Feedback on Karangahape Road enhancements

The Karangahape Road (K Road) enhancement project is a joint project between Auckland Council and Auckland Transport (AT), which aims to preserve the road's unique character and create a street environment that supports the local community and meets the needs of a growing population.

Image: Proposed layout for Section 4 (Upper Queen Street).
More detailed plans are available on the project webpage.

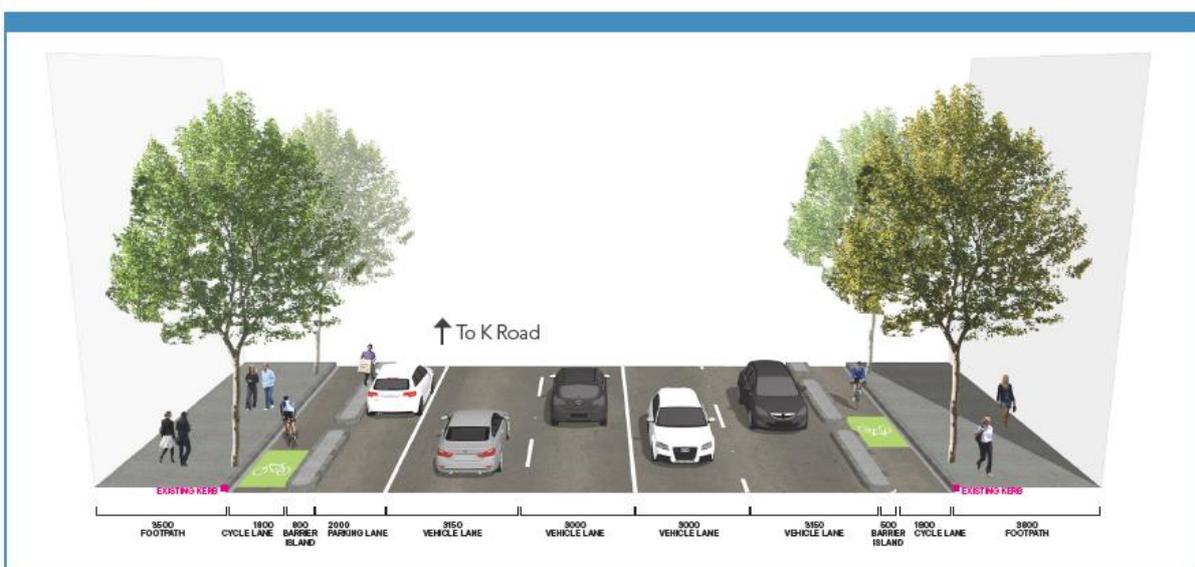
Please note this drawing contains an error. The existing painted median strip in the centre of the road is not shown in this drawing, however, it will be retained. Please see the [project plans](#) for the design for this section.
